**Pre-bid Meeting Minutes/ Addendum No. 2**

**PAL 10-00047395: Construction of Khan Younis Waste Water Treatment Plant (KY WWTP)**

**ITB-PAL-0000089780: Rehabilitation of Pumping Stations No. 08, 03 and 02 in Khan Younis for KY WWTP**

PS3 SYSTEM CHEMATIC DIAGRAM

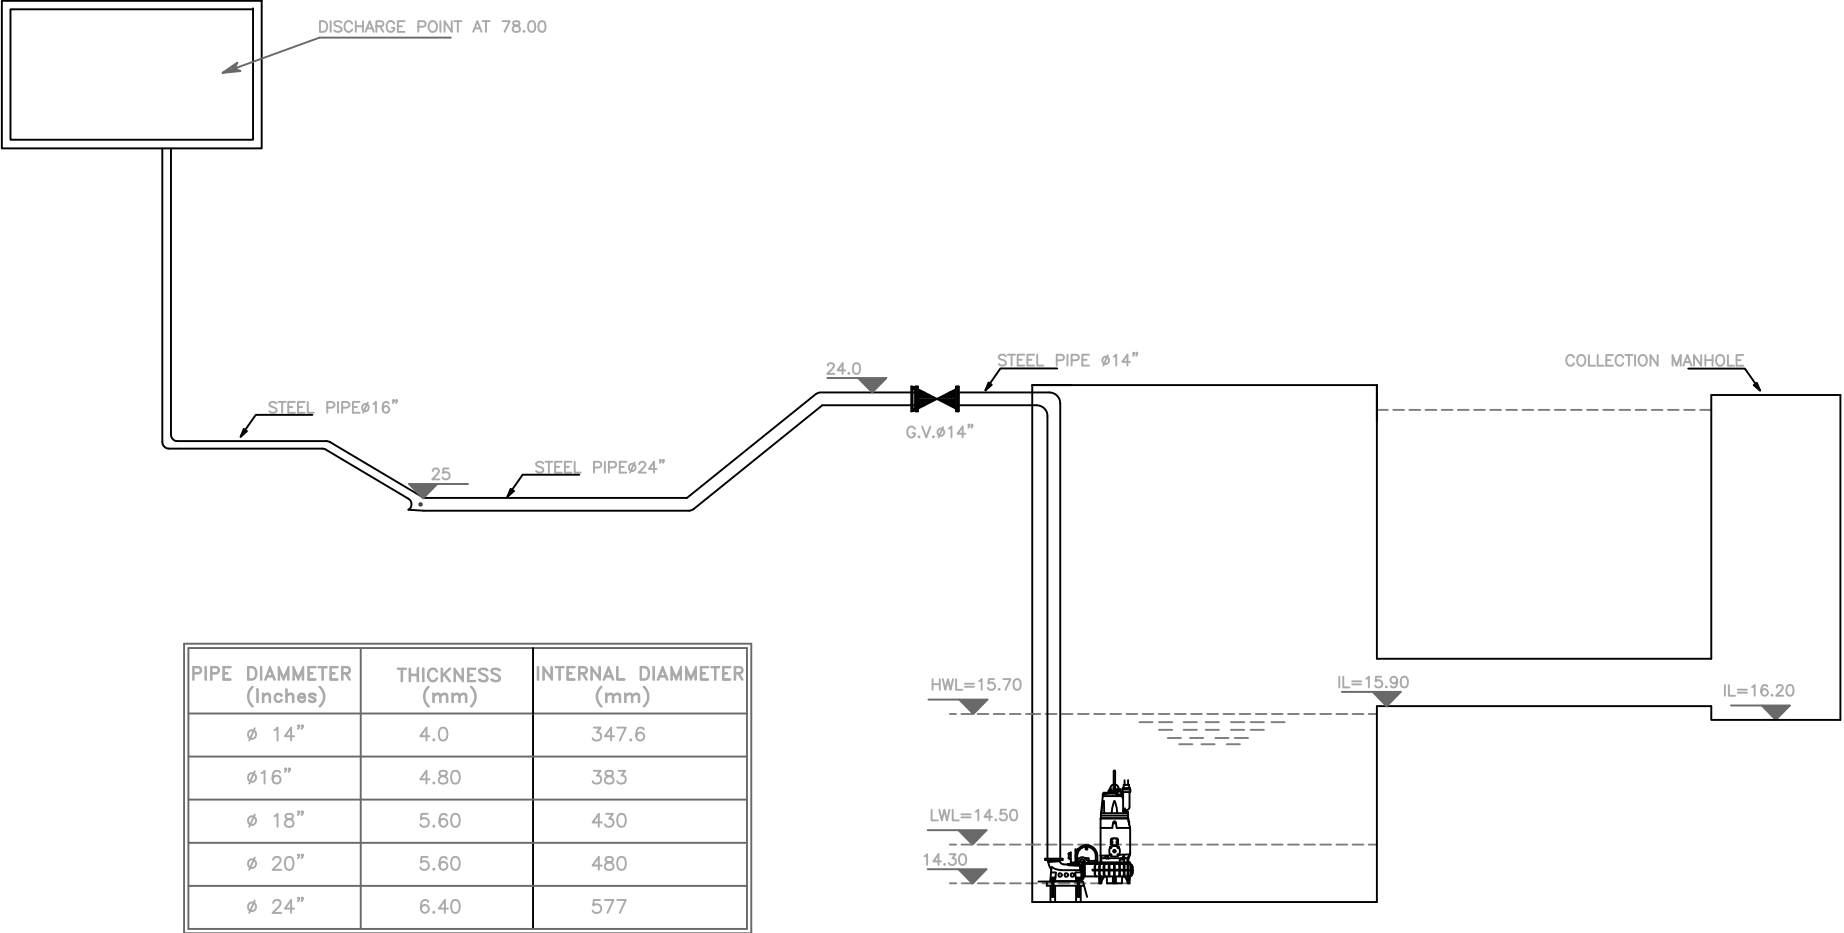
No	Enquiries	Answers
1	Reference to item 5.3 in page 27 in the BOQ, kindly provide us with the following to be able to design and price the surge tank: 1- Complete force main pipe profile. 2- Pipe diameter and material. 3- Flow rate (1 pump, 2 pumps in operation, etc.) 4- Working pressure.	The length of the pressure pipe is 3,400 metres (the first portion of the discharge pipe is from Al Wafia pumping station no. 3 to Jamal Abed Al Naser street with around 300 metres and the pipe material is cement lined steel with 24" diameter and steel wall thickness 3/16 inch. The second portion is 3,100 metres and the pipe material is cement lined steel with 16 inch diameter and steel wall thickness 3/16 inch). The flow rate will be 600 m <sup>3</sup> /hr at 79 metres' head. Schematic diagram with profile for the discharge pipe of PS 3, along with some details for pumps connections & installations are given in annex 1. The contractor shall be responsible for the check and verification for these information and any other required information and data with Khan Younis Municipality and on site and shall be responsible for appropriate and proper design, installation and commissioning of the surge tank.

**Pump guiding holder for new pumps installation**

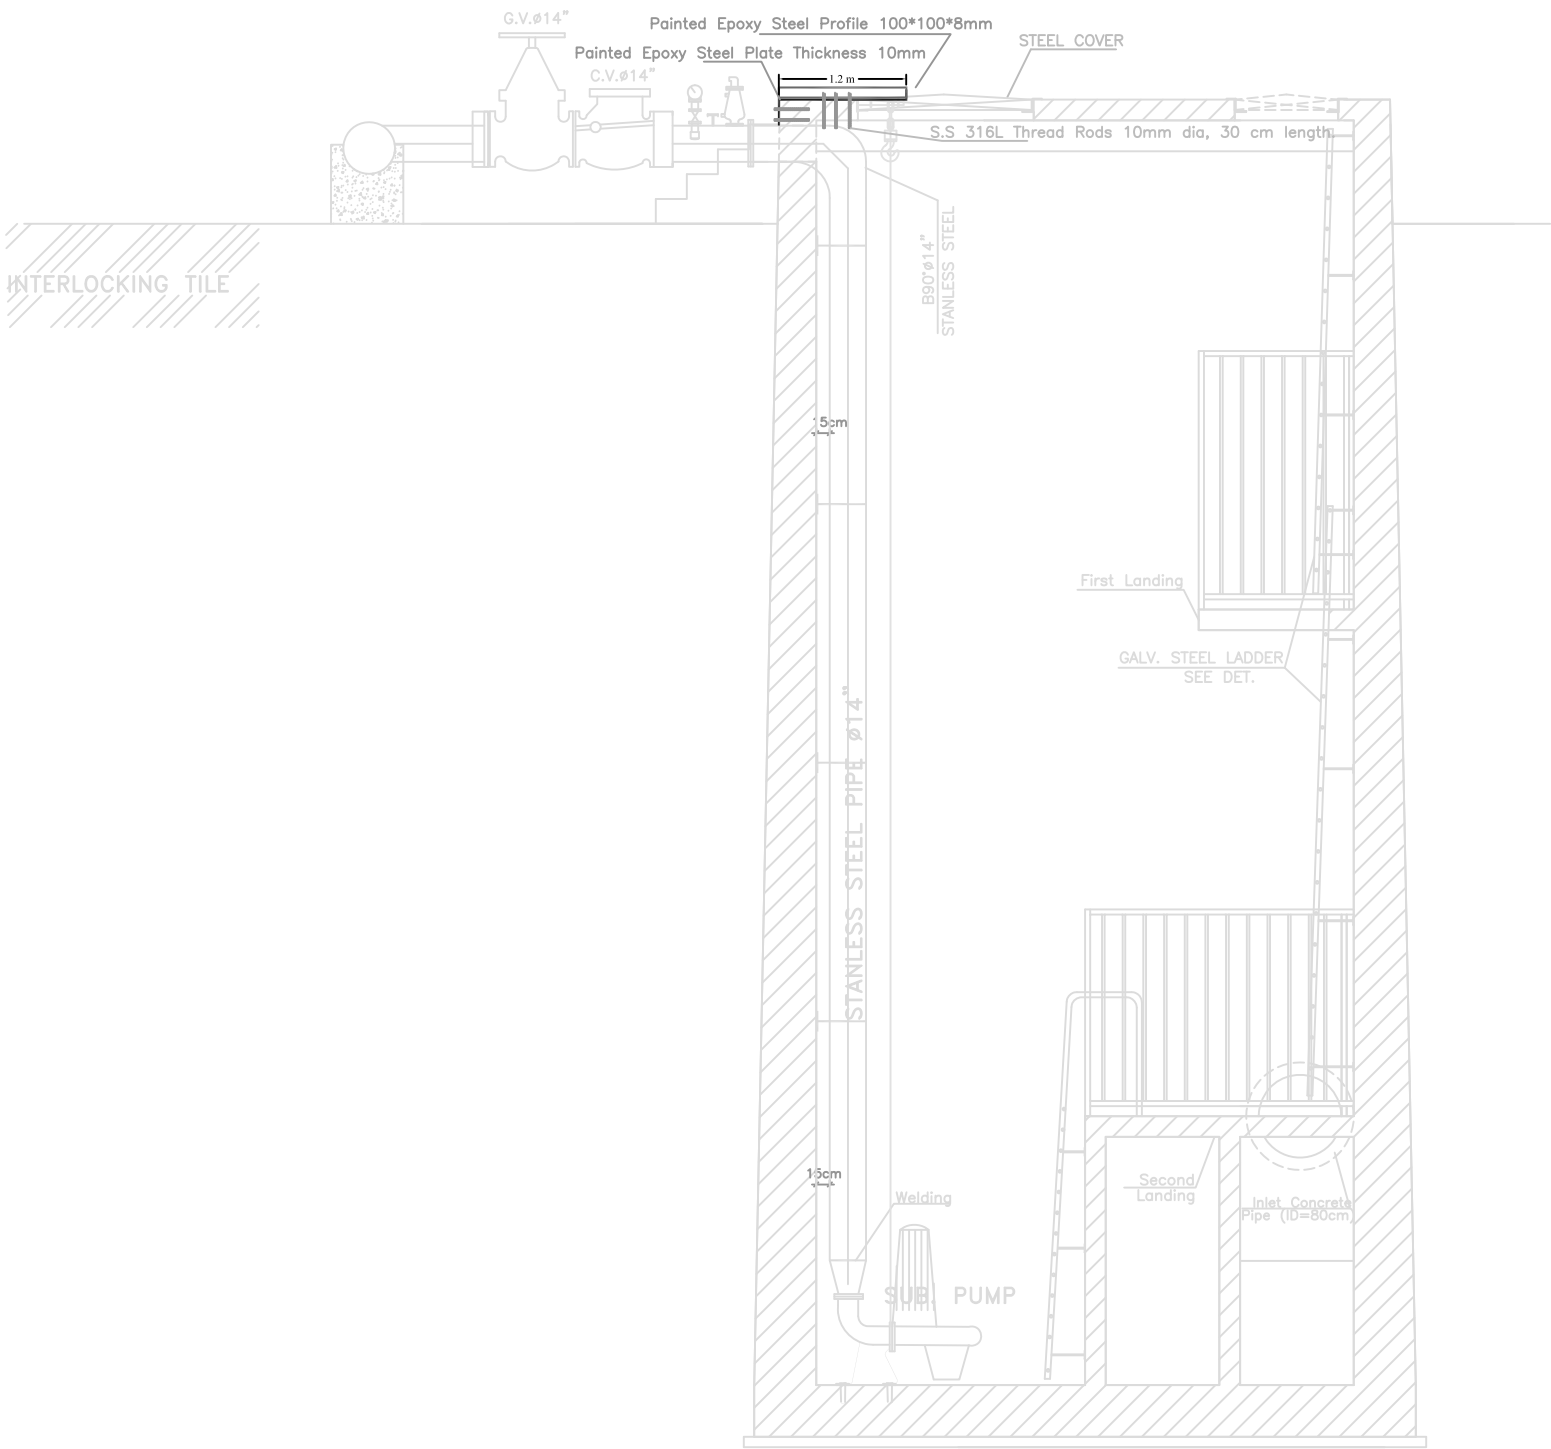
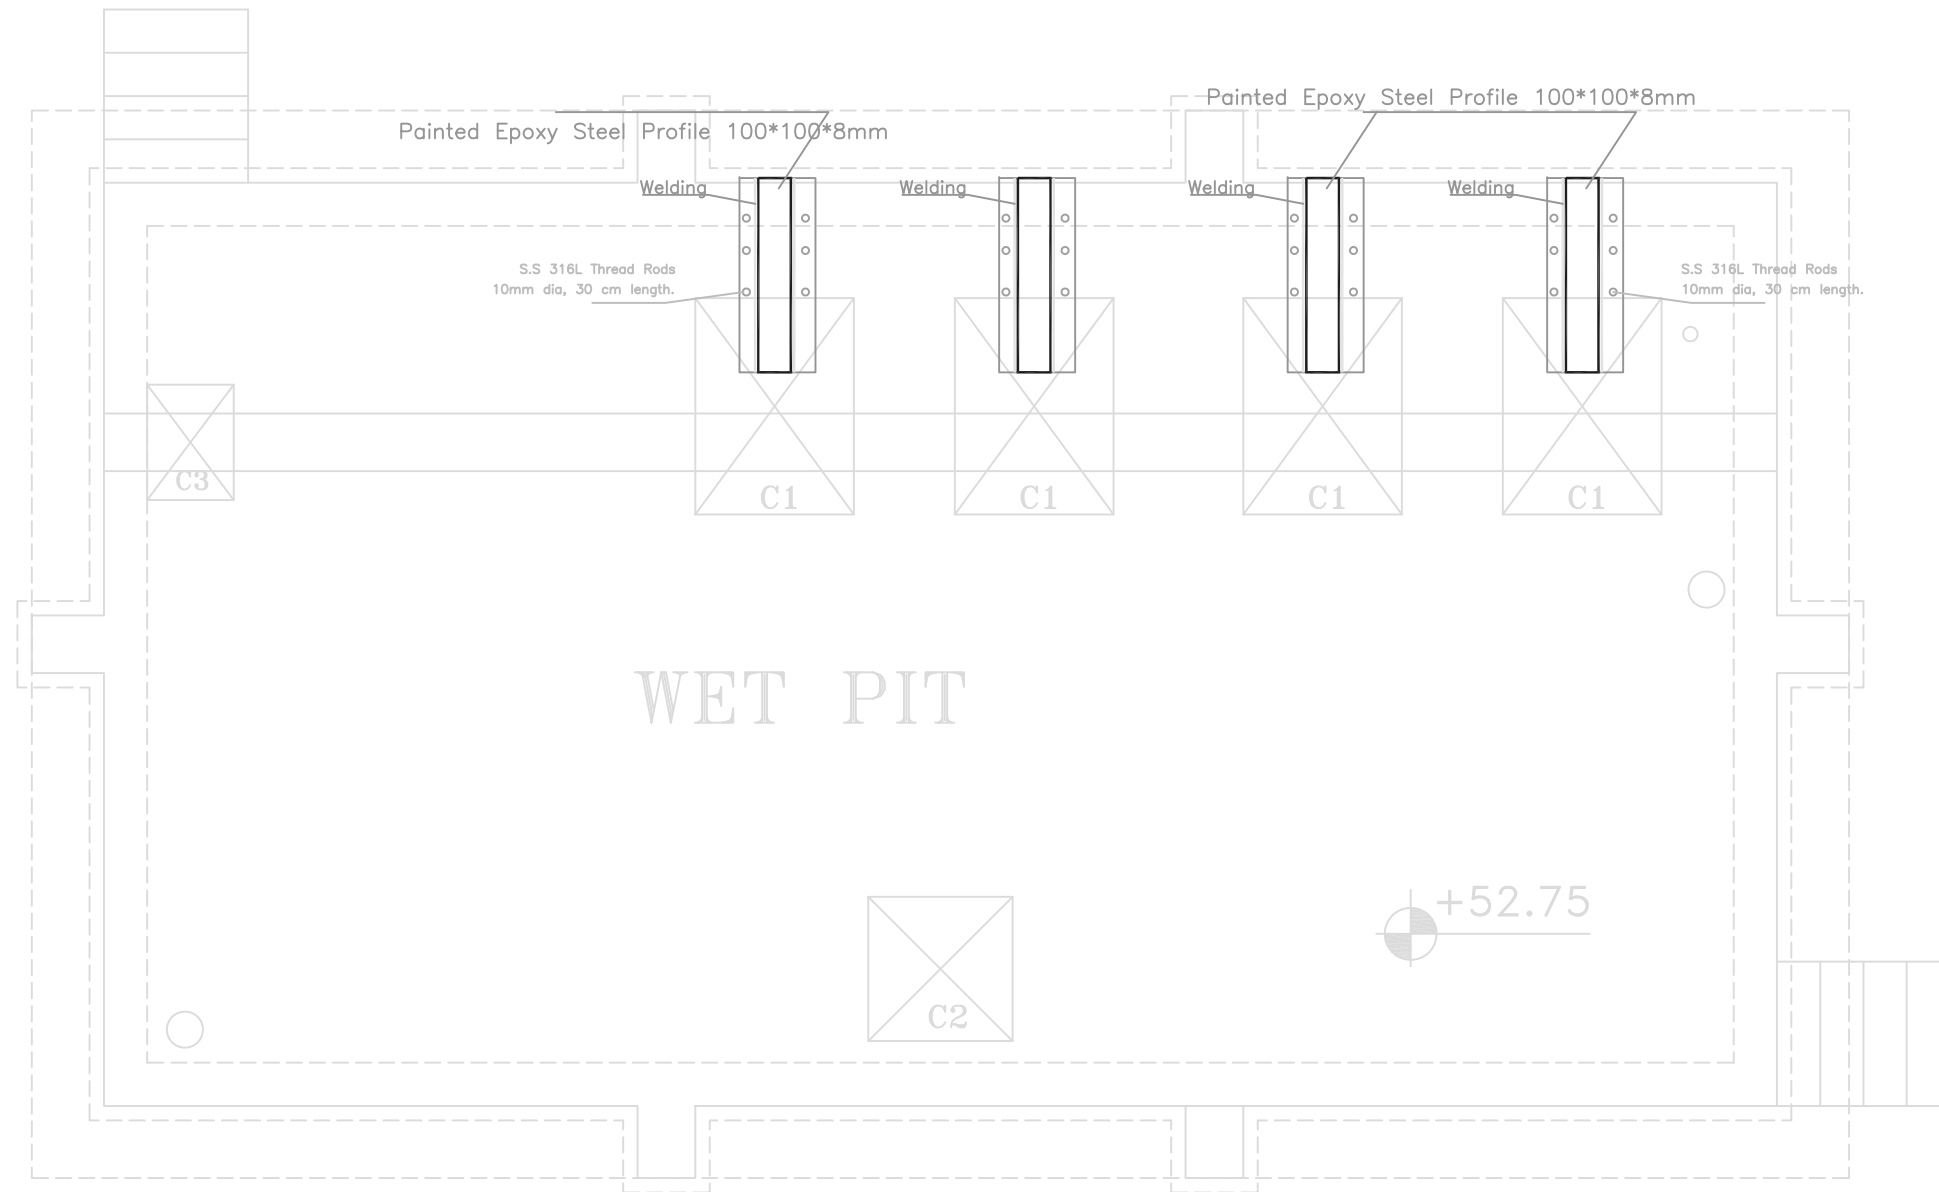
36. For item 1.3.1 page 10 in the bill of quantities (BOQ), the contractor shall consider in his pricing supplying and installing a complete stainless steel 316L supporting holder made of profile 100\*100\*8 mm for carrying and fixing the pump guide holder with all needed bolts, nuts, anchors, fixing plate 10mm with all required fabrication works for the opening gates. The same is required for items 5.1 and 5.2 in page 26 and as per the attached detailed drawing included within this addendum No. 2.

DRAWING NAME : SITE LAYOUT

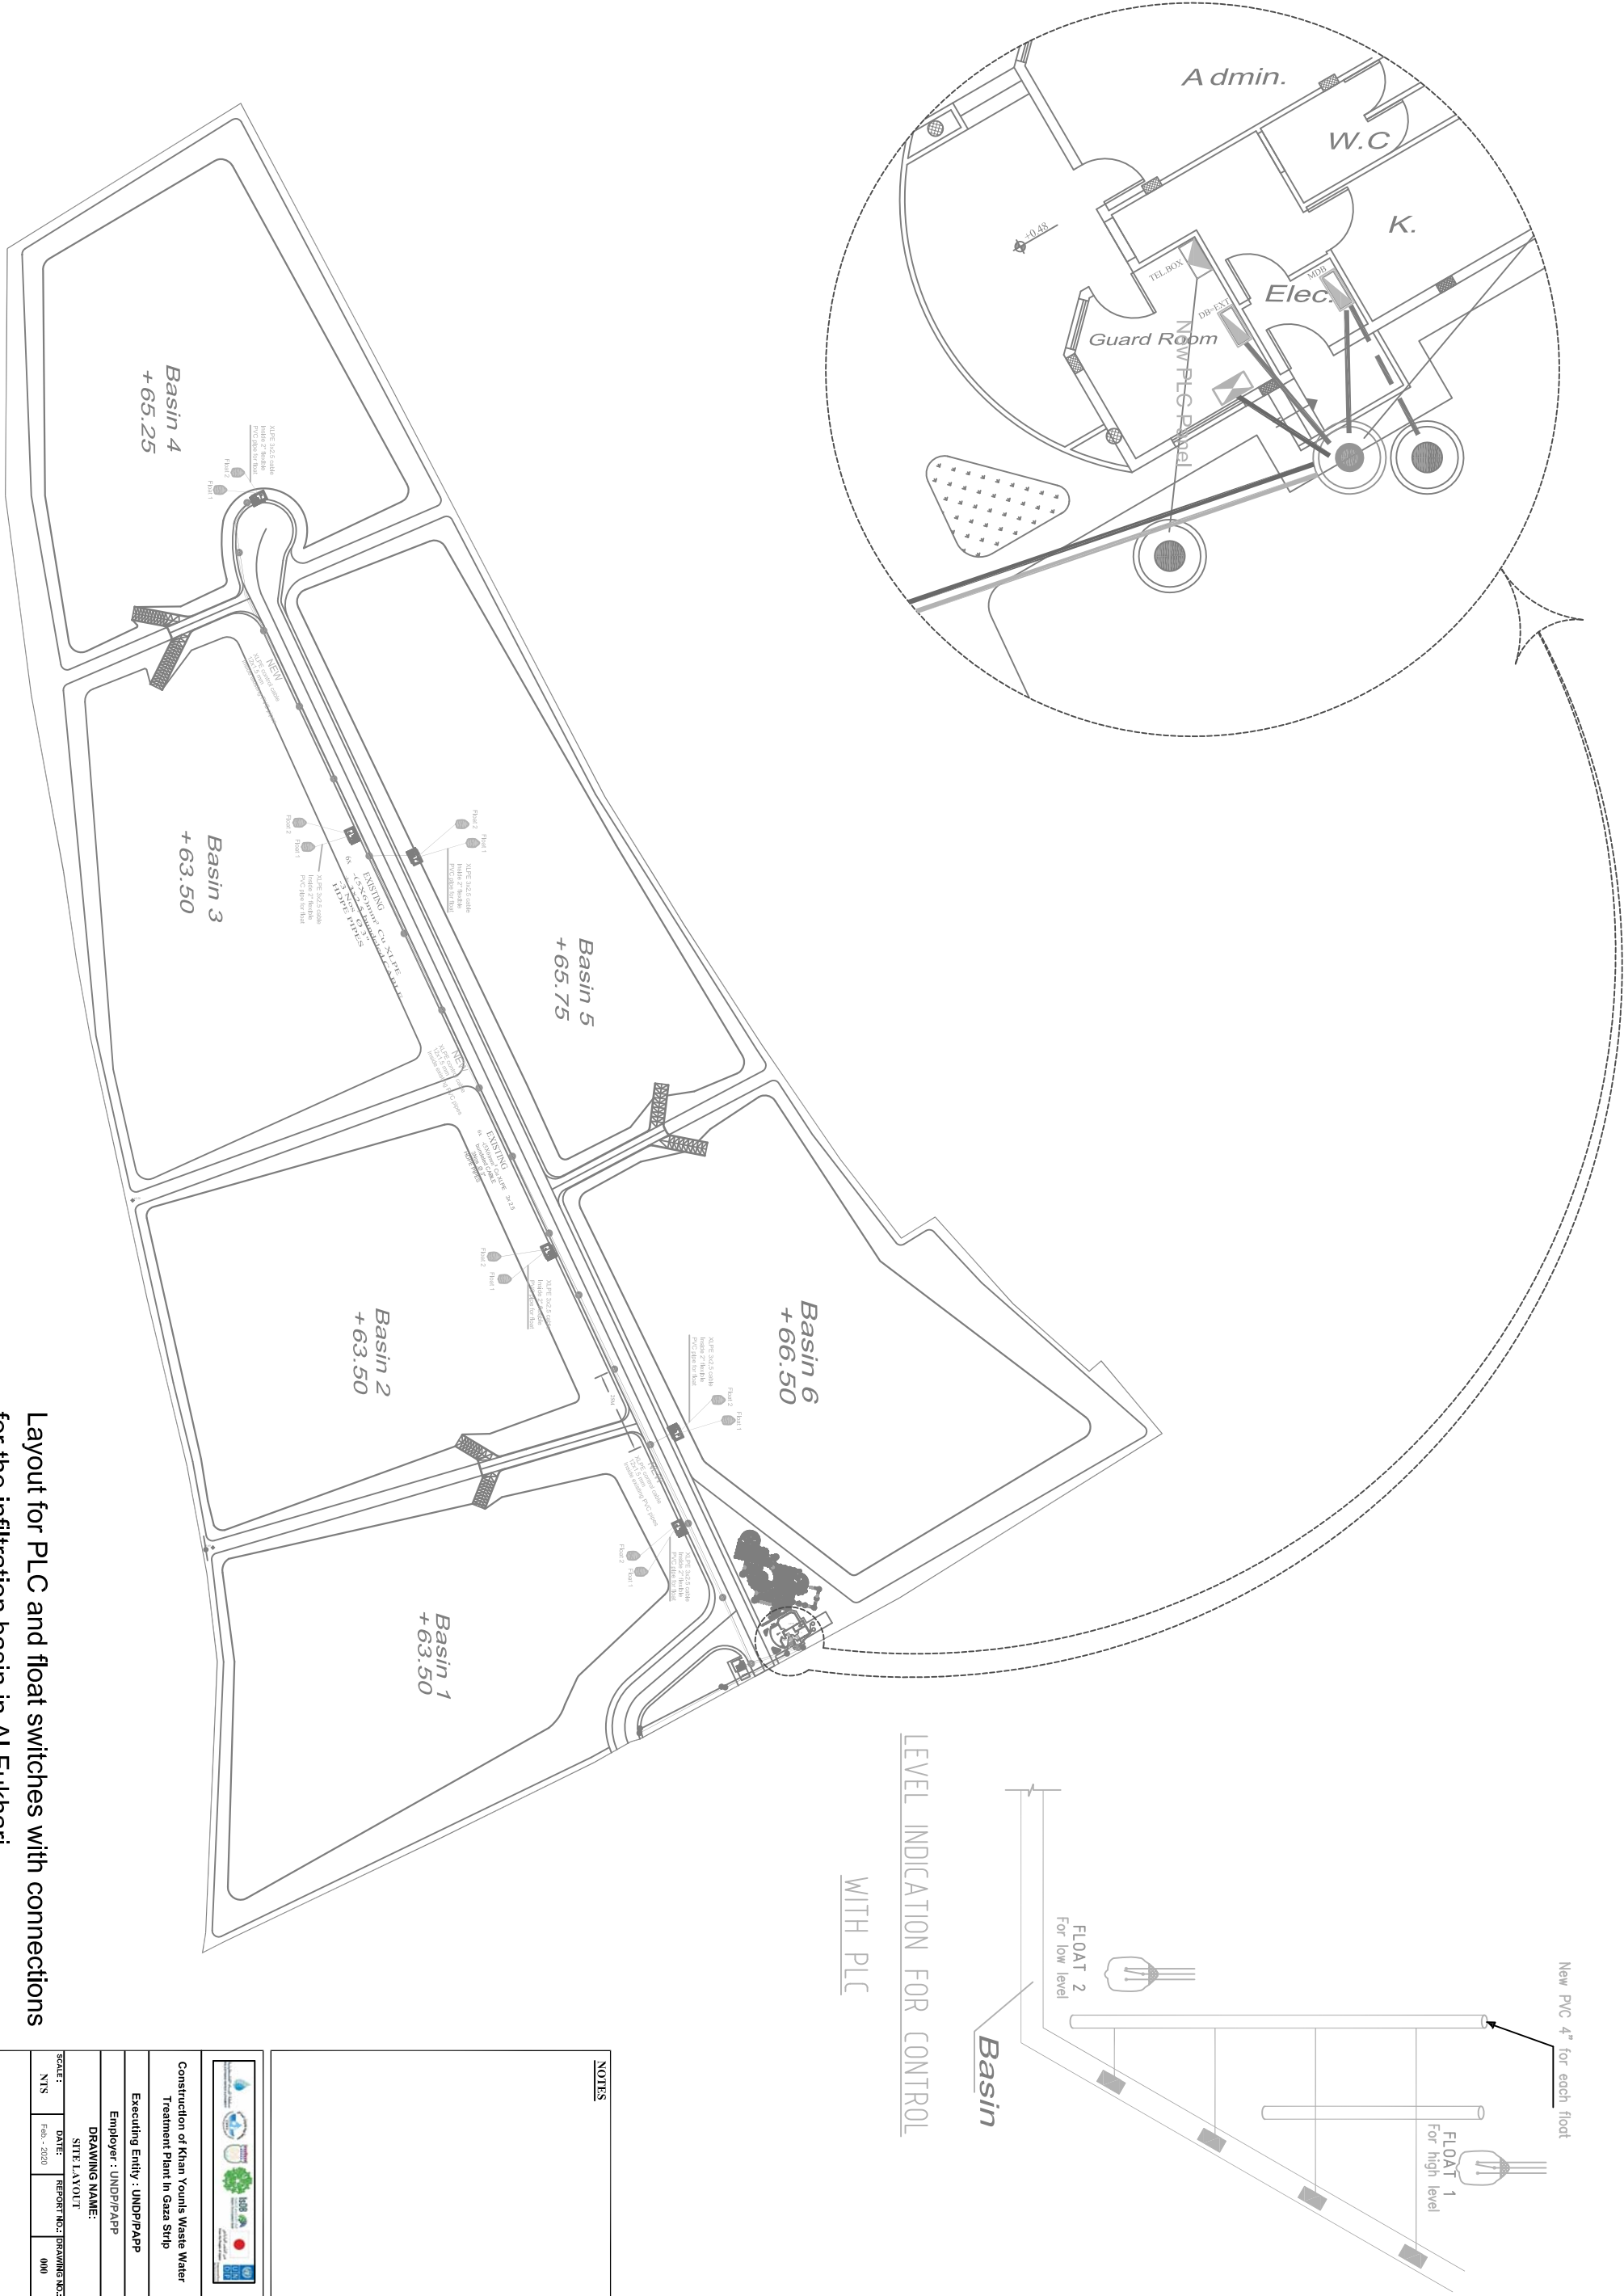
6. Item 6.4 in bill 6 of the BOQ: The item and the price shall include supplying and installing UPVC pipe 4 inch to install the float inside it with all needed vertical and horizontal hot dip galvanized profiles and clamps with complete painting and concrete to fix the base of these profiles structure inside the basins. Each float shall include supplying and installing a connection box IP65 with terminals inside inlet room for control cable connections.

8. Details drawing for Bill 6 for the infiltration basins is attached as annex 2.
